# Modification Recommended Service Note

## N8930A - Autoranging System DC Power Supply, 1000V, 30A, 10000W, 208 VAC

Serial Numbers: DE14290000 - DE15369999 without manufacturing ID Version "B"

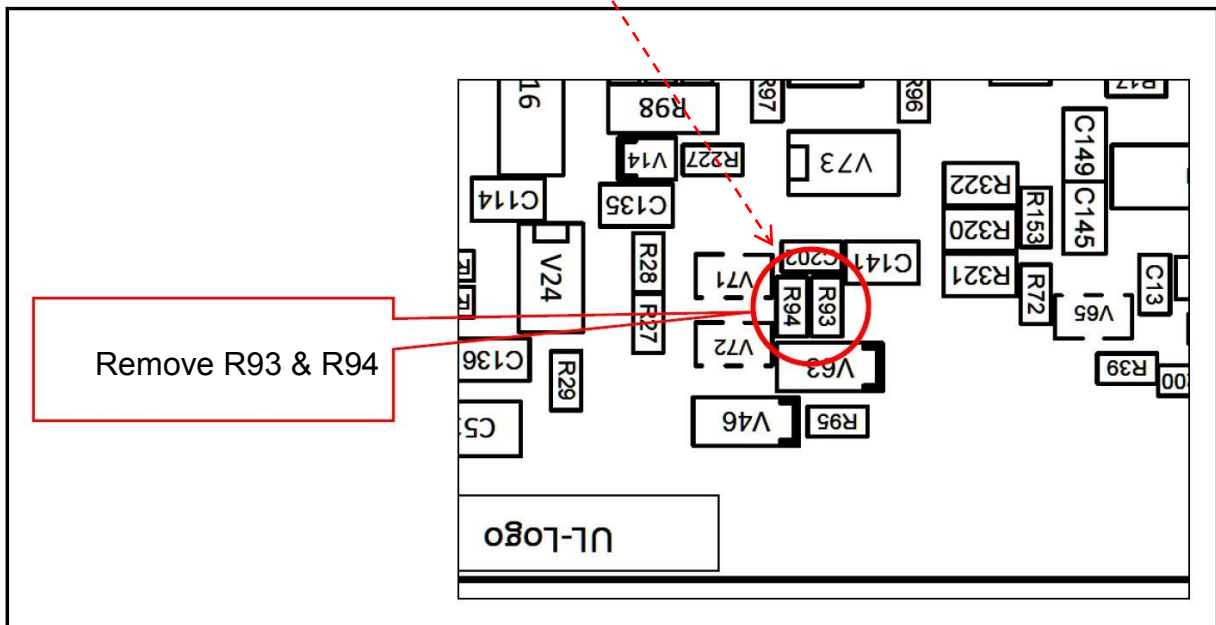
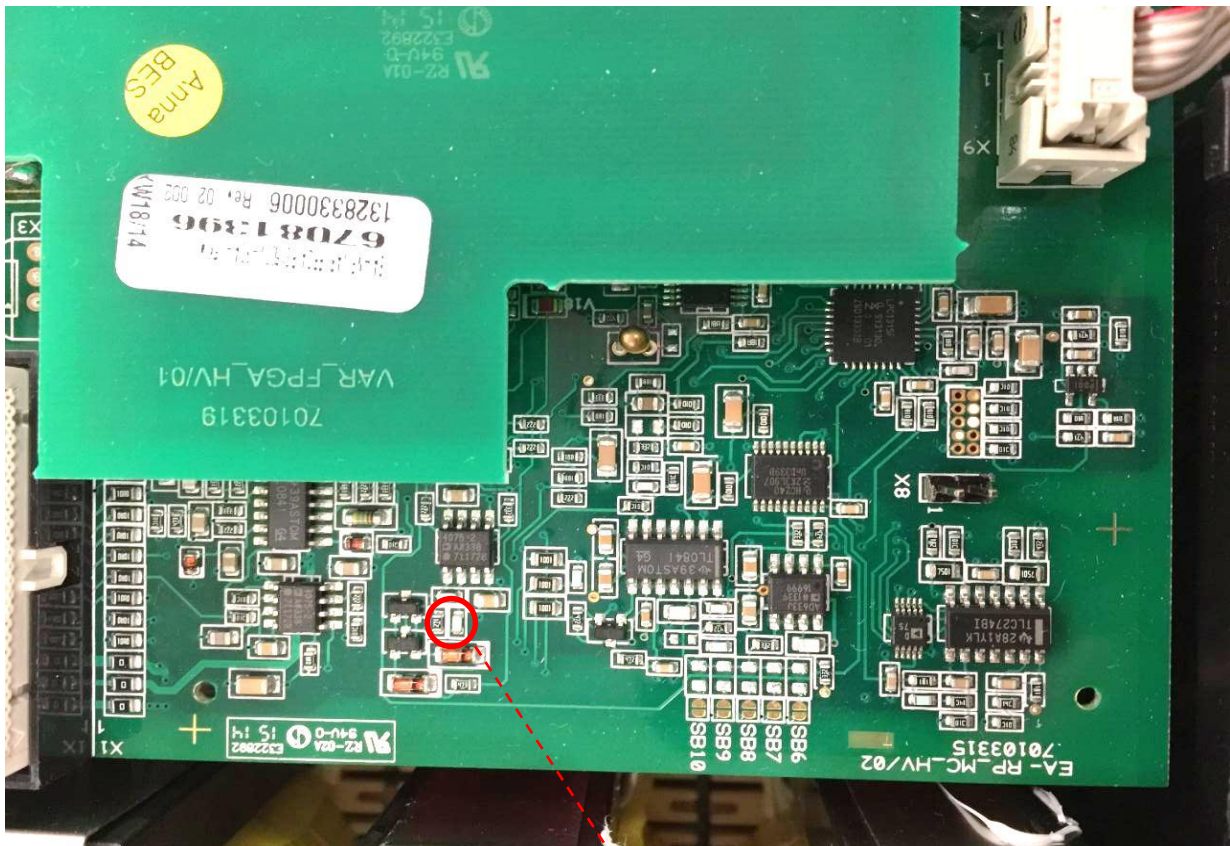
- 1) Remove acMains cable from power source.
- 2) Wait 5 minutes
- 3) Remove top cover from instrument.
- 4) In the 5kW units (viewed from the front of the unit), a small SMT assembly located at the right-rear of instrument will be readily visible (see below):

In the 10kW & 15kW units; although found in the same location, a black plastic cover will have to be removed to gain visibility and access to the SMT assembly. Plastic cover snaps-on and can be removed with a small screwdriver.

5) SMT resistors R93/94 are located in red circle shown below:

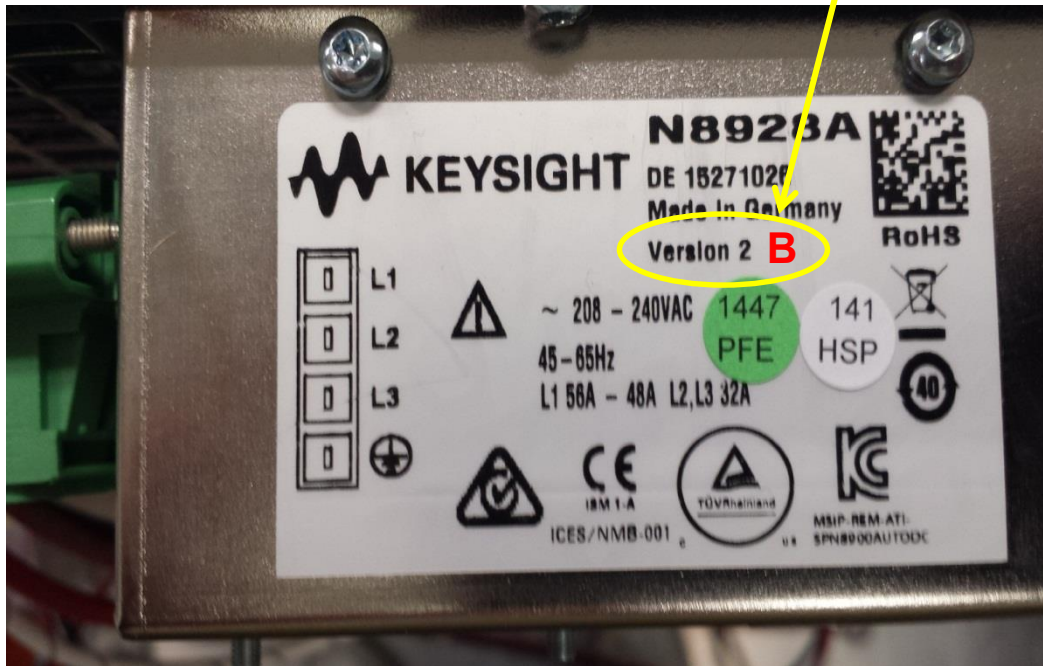
Removal of two (2) surface mount resistors, R93 and R94, will correct this problem:

Resistors R93 and R94 must be removed, no replacement parts are required for modification.
